Anonymous Referee #2, 13 May 2026

Report #2

This study presents the implementation of an “urban” tile in the ORCHIDEE land cover and vegetation model for future applications in climate modeling at various spatial scales. The evaluation of energy fluxes is based on the Urban-Plumber database, and shows a nearly systematic improvement in modeling of sensible and latent heat fluxes which demonstrates the added value of the new parameterization. However, some biases persist in ORCHIDEE: it would be relevant to suggest some ways to improve the model and to assess the model’s sensitivity to certain parameters (e.g. roughness and drag coefficient). For the hydrological component, one limitation of the study is the lack of data needed to conduct an objective evaluation. Consequently, this section presents only a sensitivity analysis comparing the different ORCHIDEE configurations, which makes it difficult to critically analyze the results. We would expect to gain a better understanding of the specific characteristics of certain sites that result in a “non-linear” response from the Urban2 version comparing to Urban1.

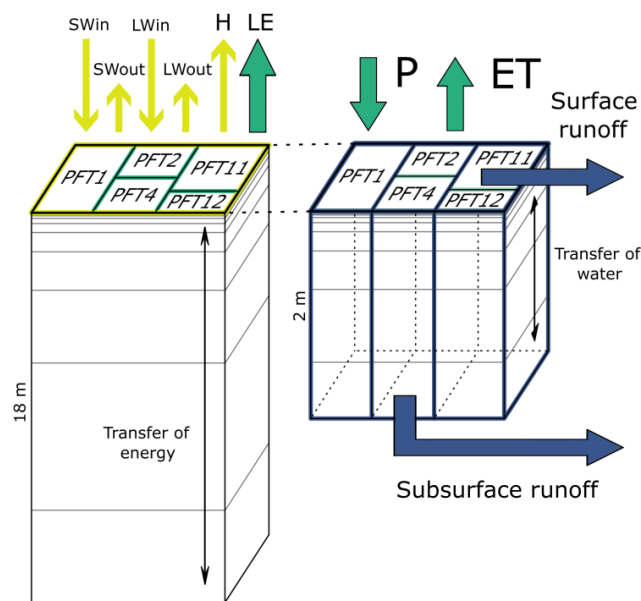
Also it is essential to include a figure illustrating the discretization/description of the grid and the soil column for modeling hydrology and thermal processes.

We now include this new figure to present the model:

Section 4.1

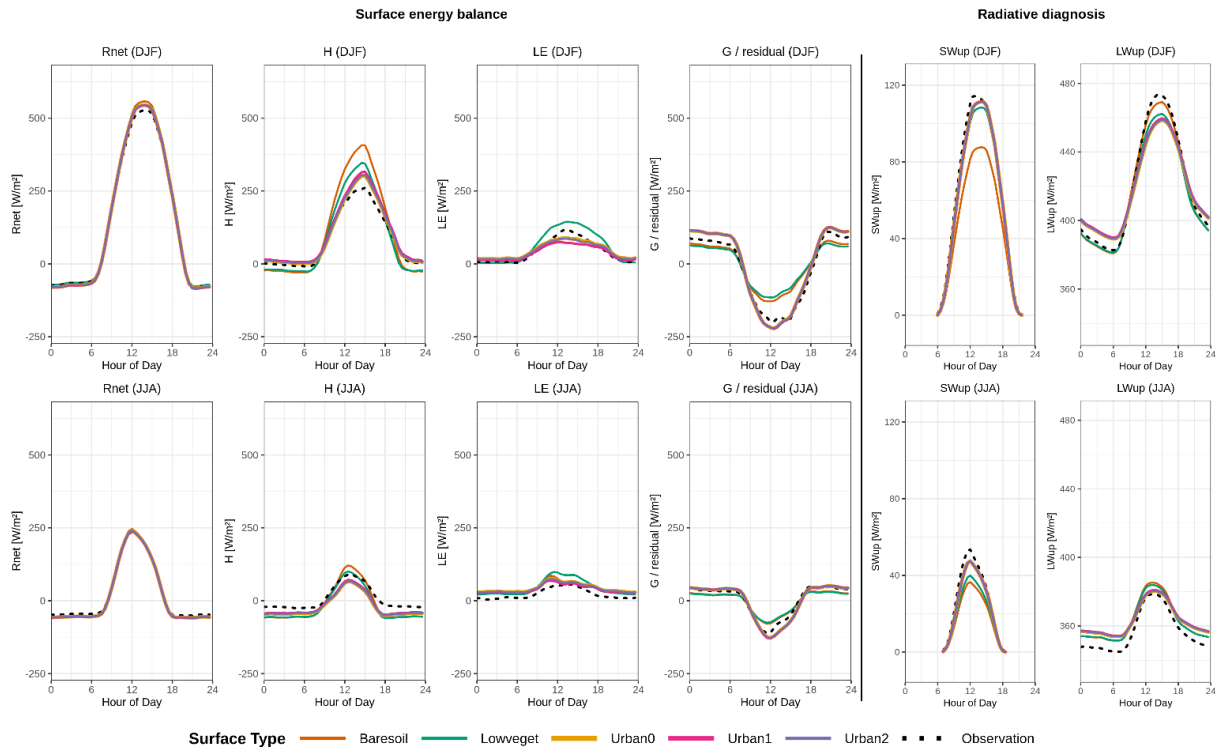
- It seems to me that the Urban-Plumber database provide incoming and upwelling solar and IR radiation terms. It would be useful to compare observed and simulated upwelling S and L to understand the errors noted for Rnet.

- Why is the albedo prescribed to 0.141 when it is informed equal to 0.151 in the Urban-Plumber database (Table 1) ?

- Even though the heat storage flux G is not available in the Urban-Plumber database, it would be possible to compare the “residual term” of the energy budget (i.e., $R_{net} - H - LE$), given that there may be an additional anthropogenic effect (Fig 2). Is G calculated as the residual term in ORCHIDEE ?

Thank you for this suggestion. We have added the observed and simulated upwelling shortwave and longwave radiation components to Fig. 2. The incoming shortwave and longwave radiation terms are prescribed from the Urban-PLUMBER atmospheric forcing and are therefore identical across simulations, so they are not shown.

The radiative decomposition shows that Baresoil substantially underestimates upwelling shortwave radiation, while the urban configurations are closer to the observations because of their modified albedo. The urban configurations nevertheless slightly underestimate upwelling longwave radiation around midday. The remaining positive bias in Rnet therefore results rather from an underestimation of emitted longwave radiation.

The value of 0.151 reported in Table 1 corresponds to the albedo assigned to the urban PFT. However, R_{net} is calculated using the grid-cell albedo, obtained by weighting the albedos of all PFTs by their respective land-cover fractions. At AU-Preston, the grid cell also contains tree, low-vegetation, and bare-soil fractions of 0.225, 0.15, and 0.005, respectively. The resulting grid-cell albedo is therefore 0.141. We have revised the text to clarify that 0.141 refers to the grid-cell albedo, whereas 0.151 is the albedo prescribed to the urban PFT:

Thank you for this suggestion. We have added the observational energy-balance residual to Fig. 2 for a qualitative comparison with the ground heat flux simulated by ORCHIDEE. Because the ORCHIDEE sign convention defines G as negative when heat is transferred into the substrate, we plot the observational residual as $H+LE-R_{net}$, i.e. the negative of the conventional residual $R_{net}-H-LE$.

In ORCHIDEE, G is not calculated as a residual of the surface energy budget. It is explicitly computed from the temperature gradient between the surface and the upper soil or urban-substrate layer, as described in Eq. (7), and provides the upper boundary condition for the soil heat-diffusion equation. We have clarified this distinction in the revised manuscript and discuss the comparison as follows:
